STATE OF ALASKA
DEPARTMENT OF TRANSPORTATION AND PUBLIC FACILITIES

Hoonah Alaska

GENERAL LAYOUT

PROJECT NUMBER X 70006 SHEET 2 OF 6

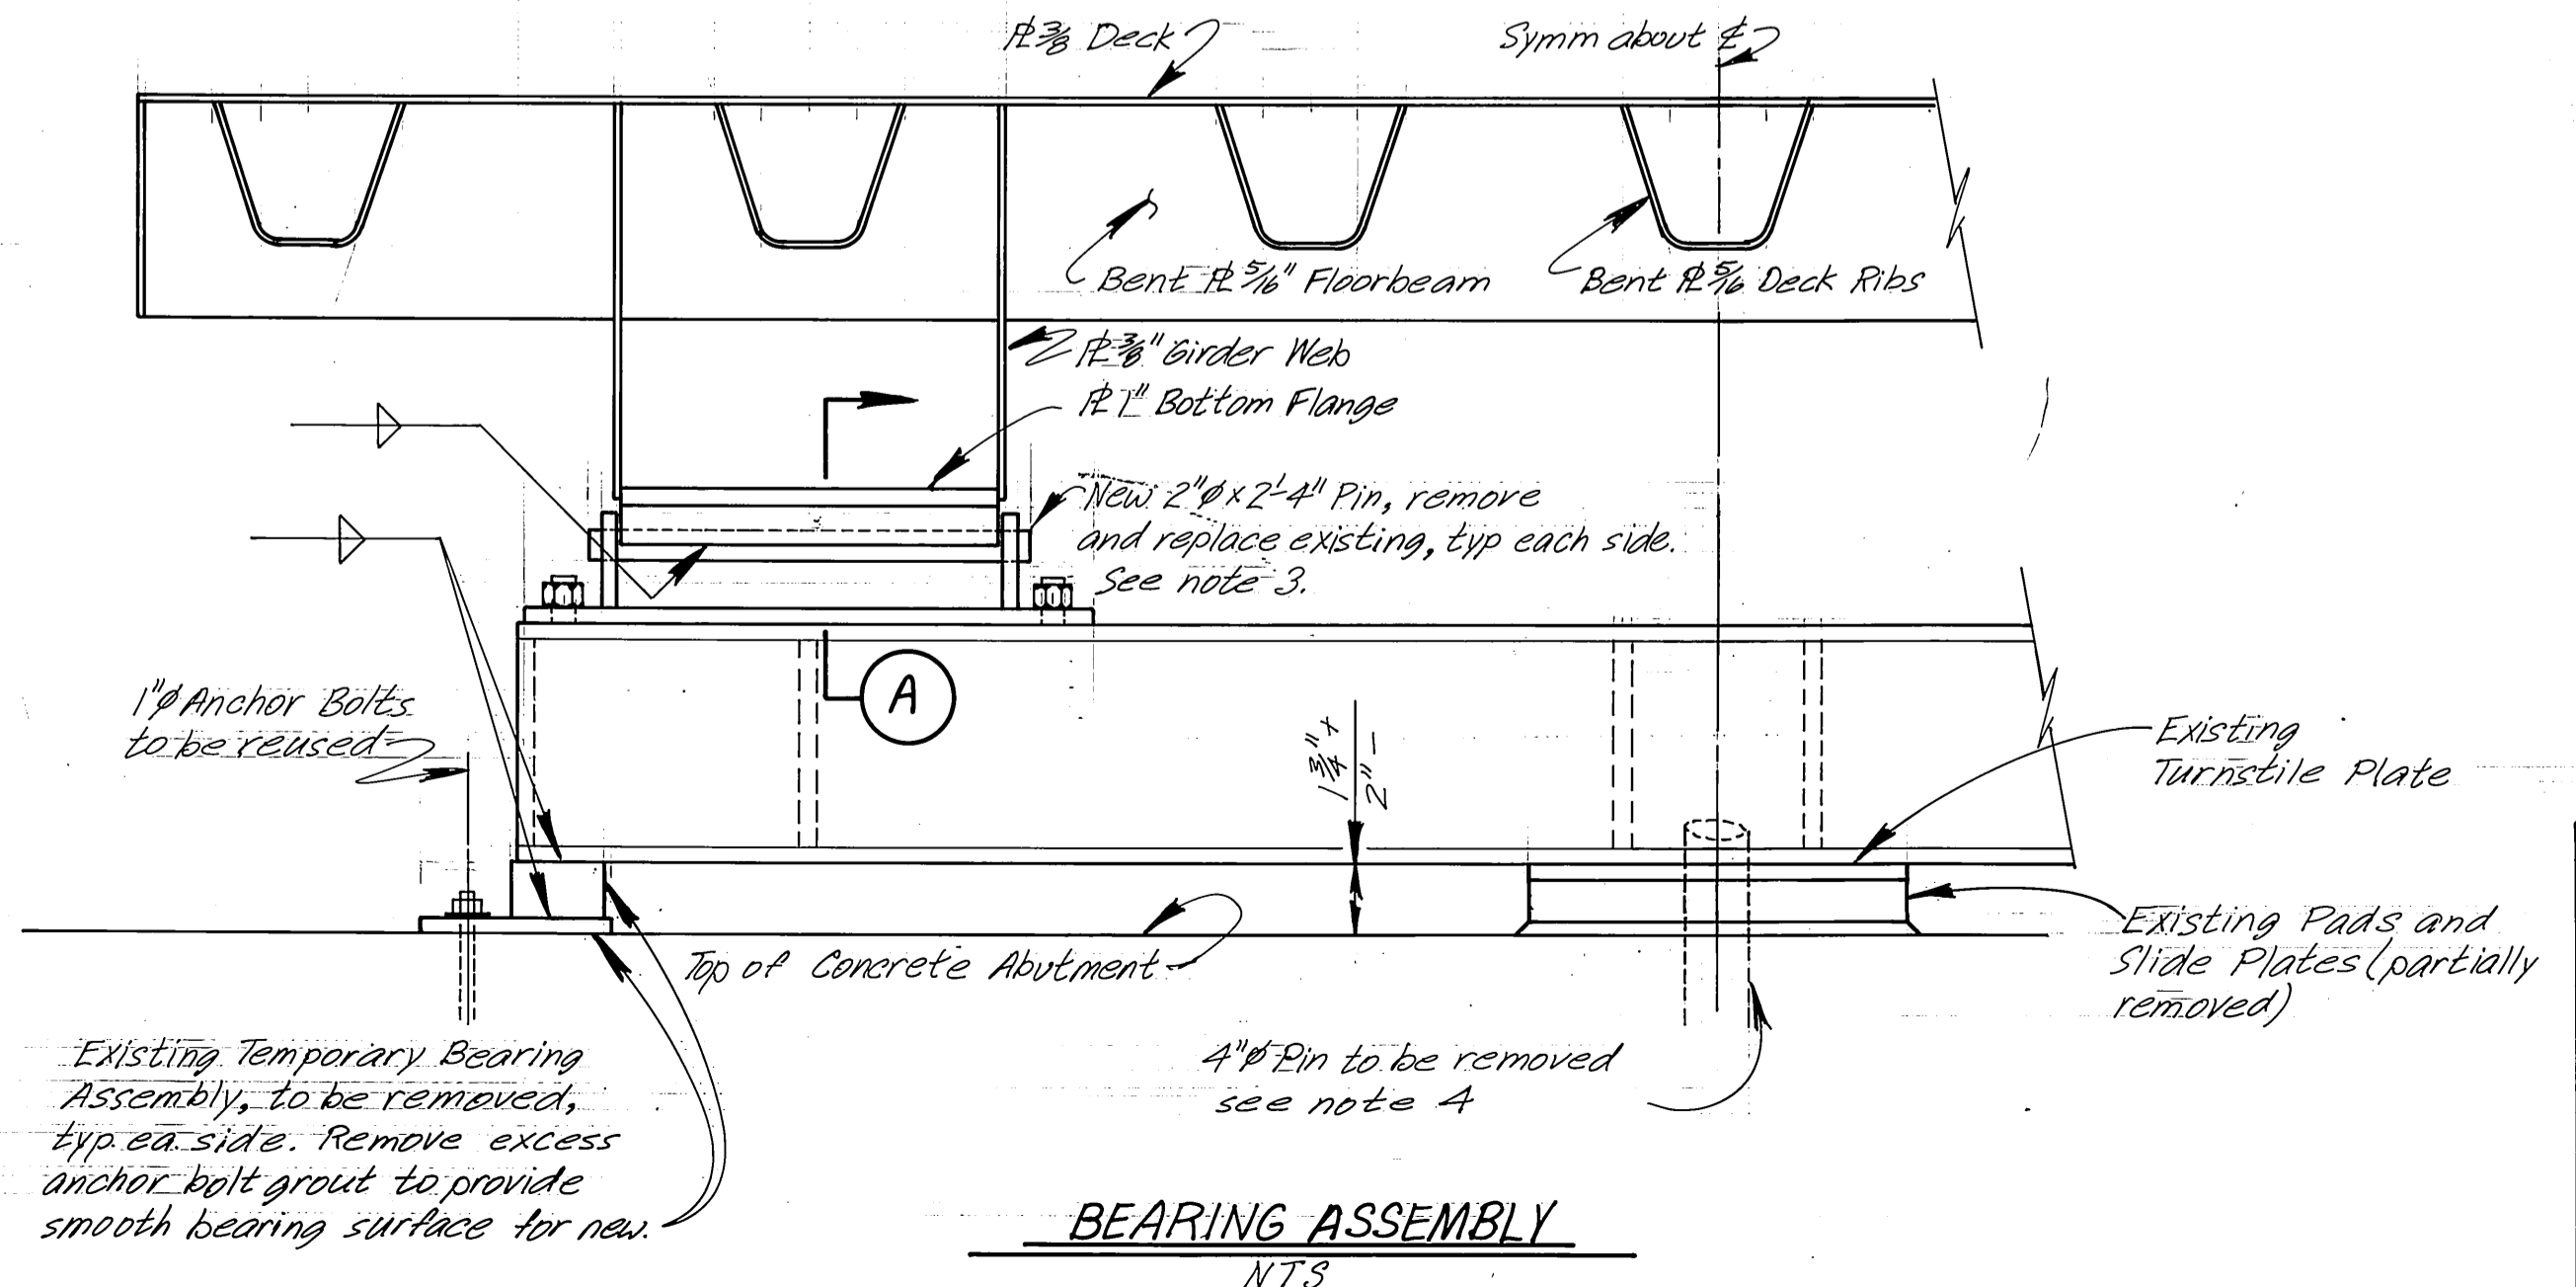
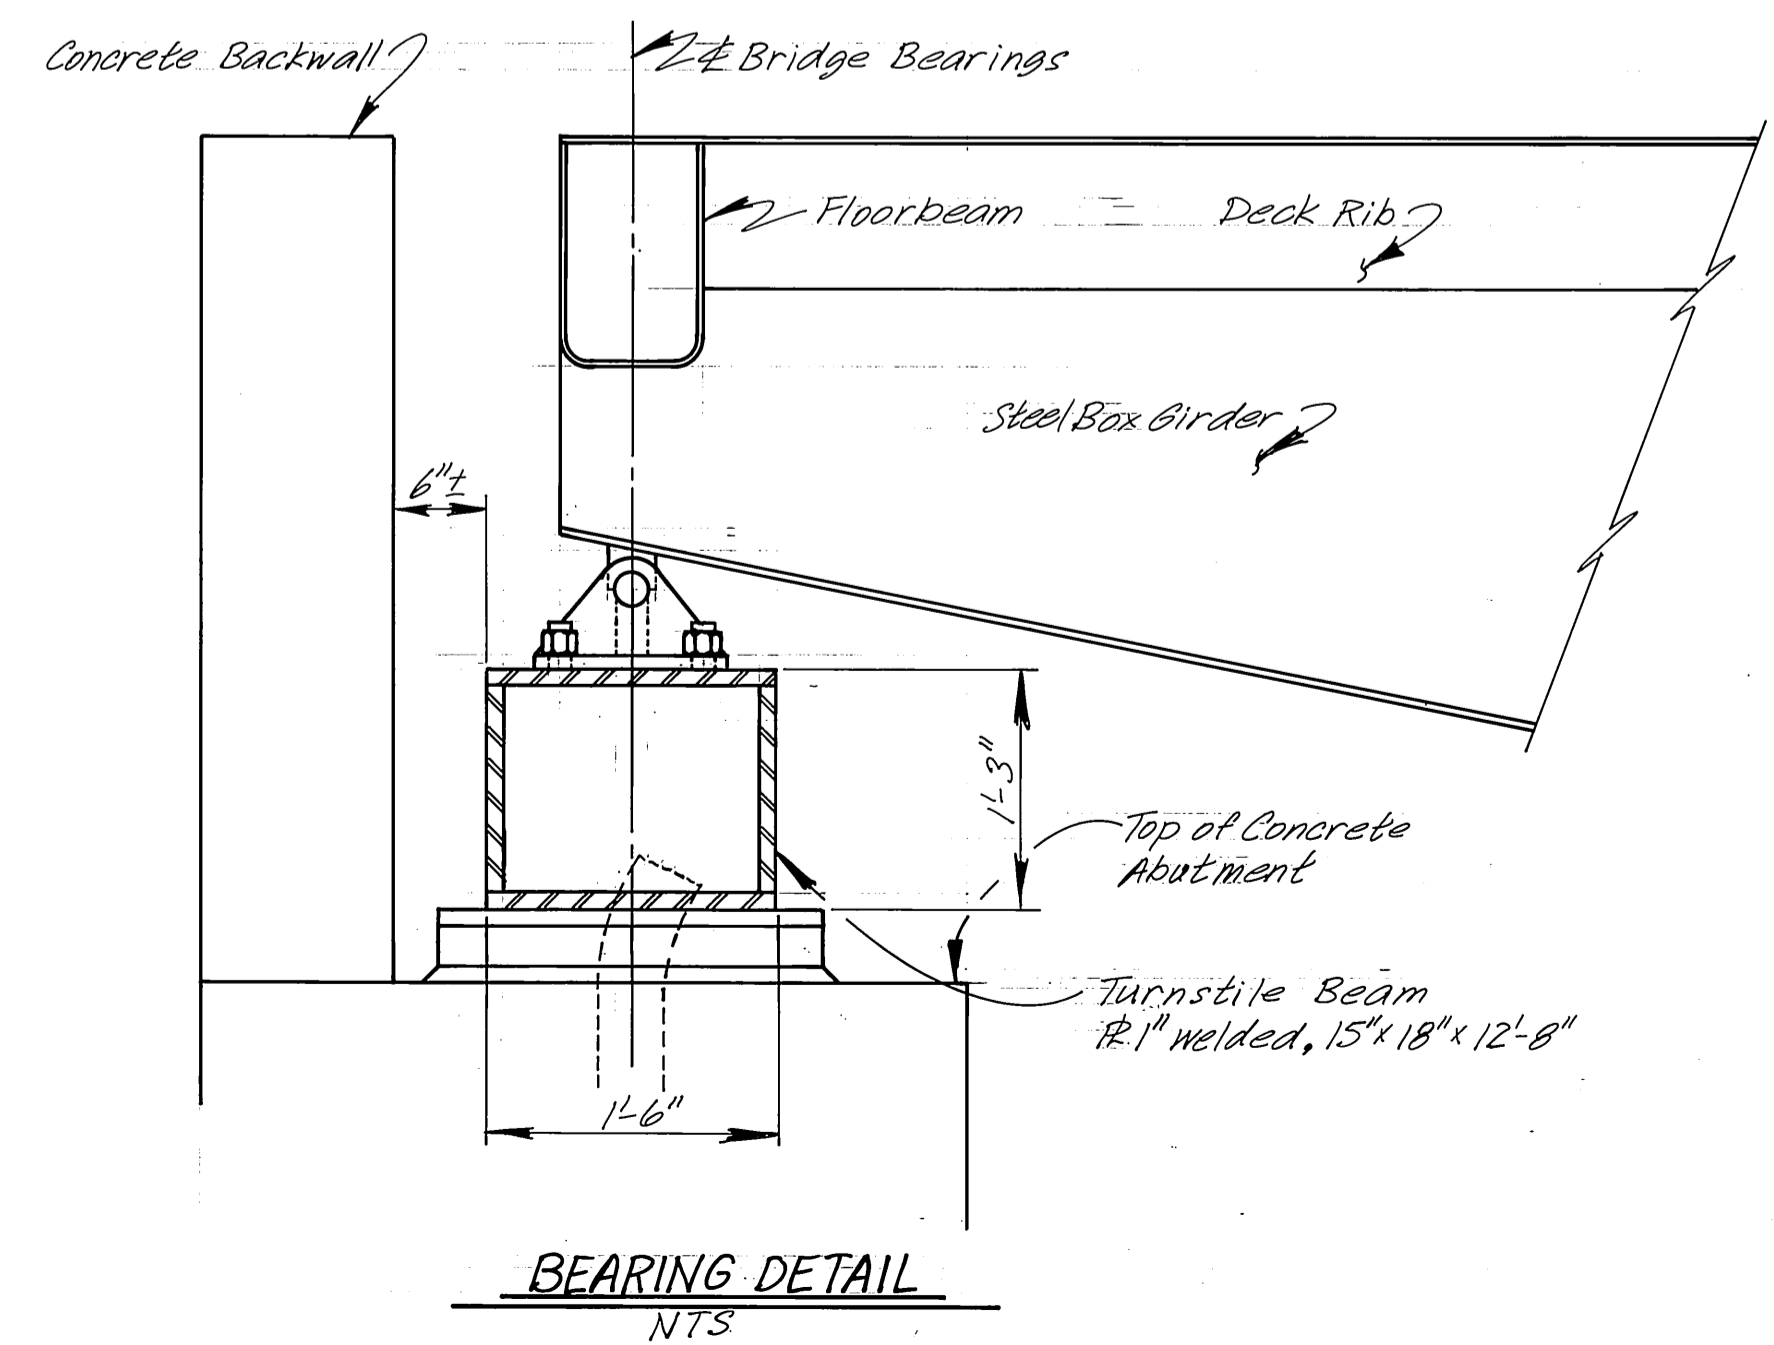
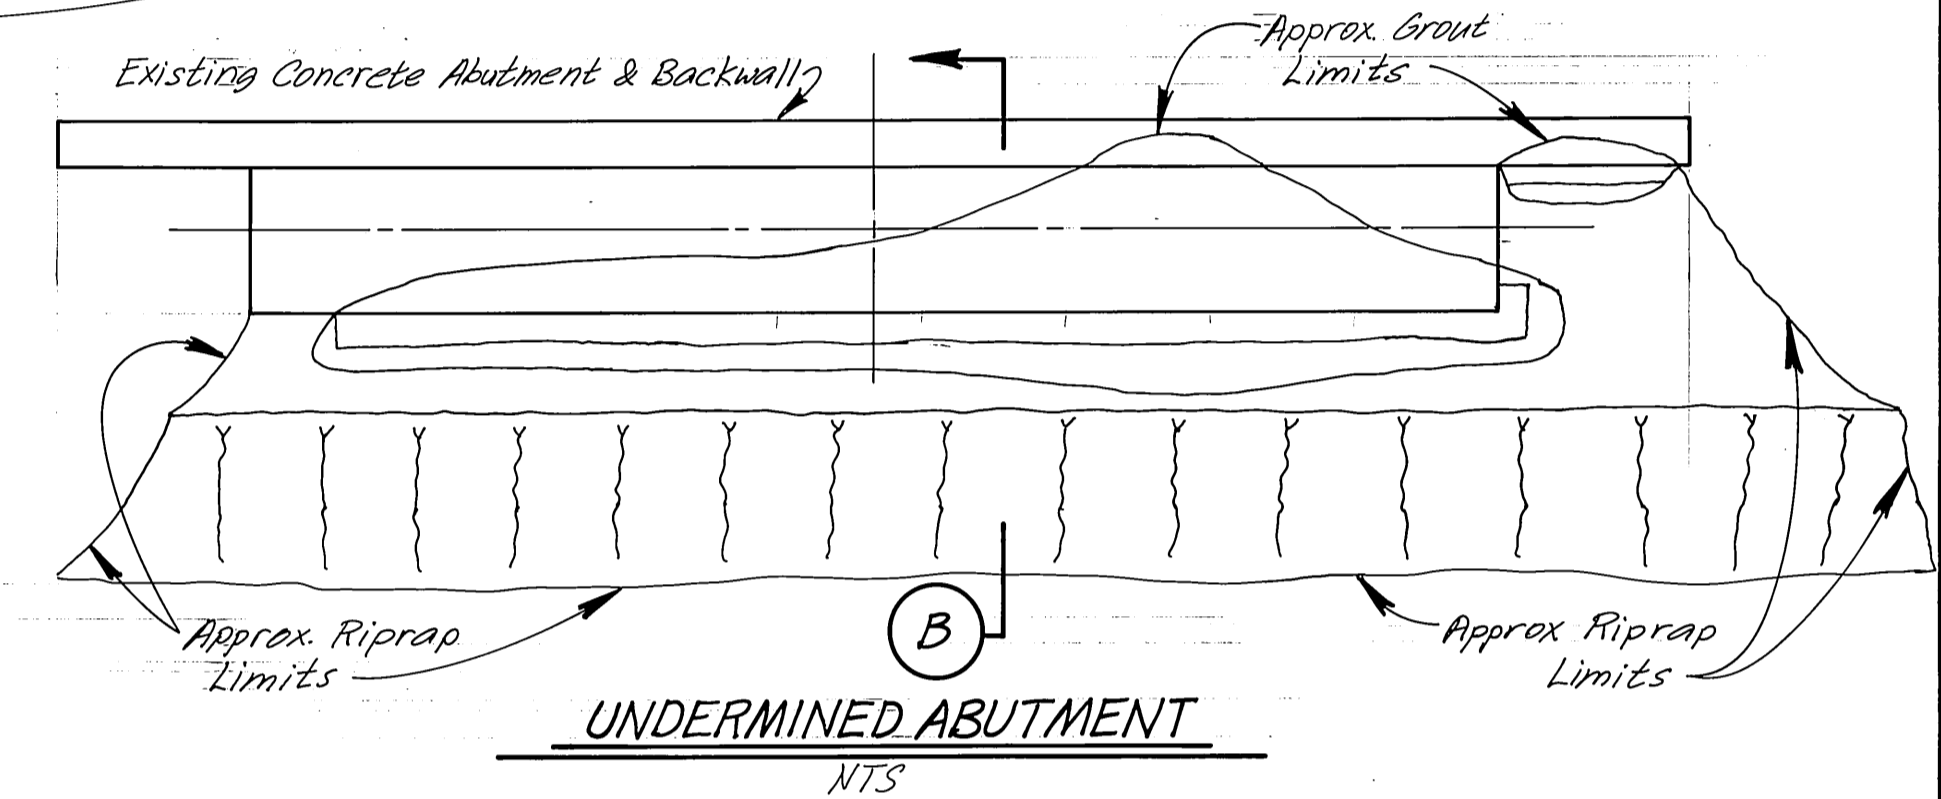
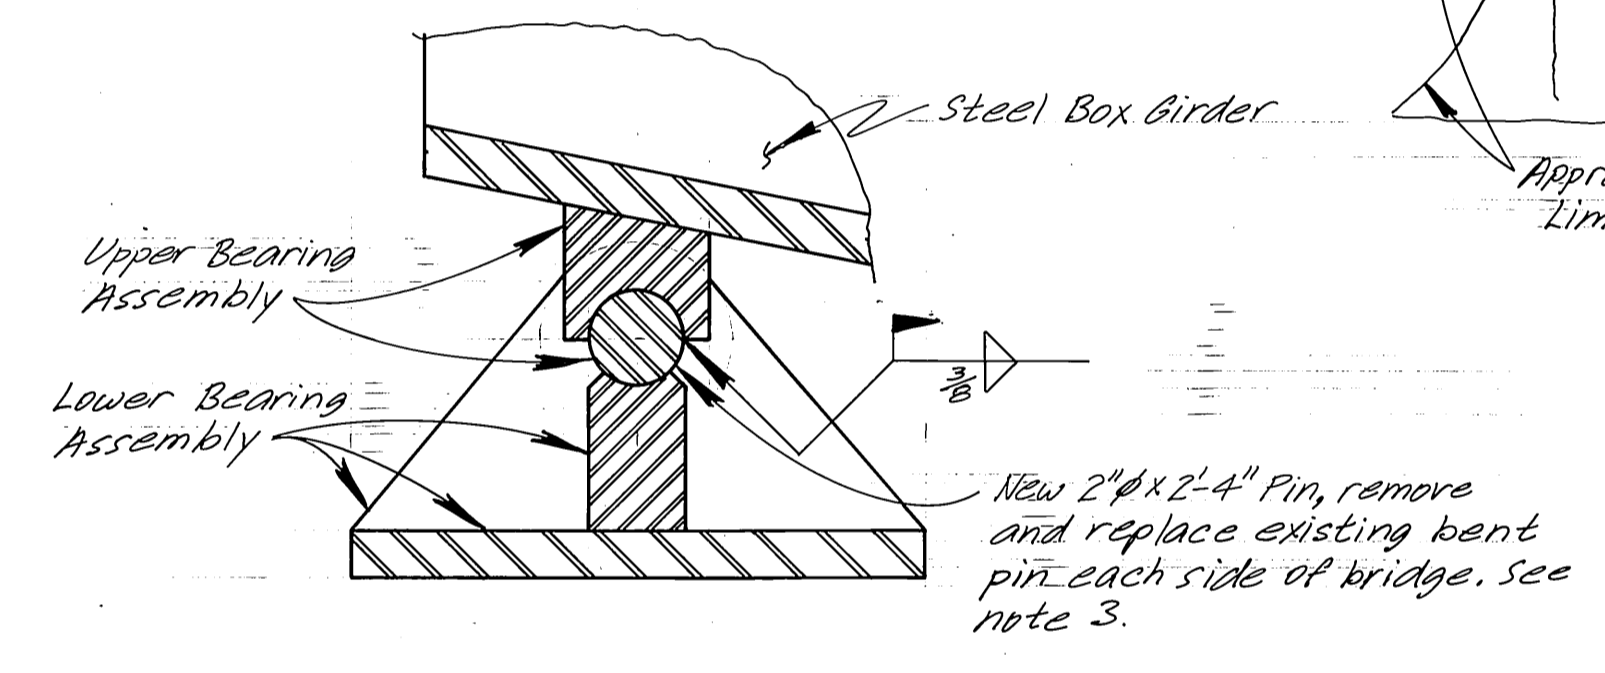
As Built Note: By job time too much erosion had occurred to use grout, therefore forms were built and concrete was poured.
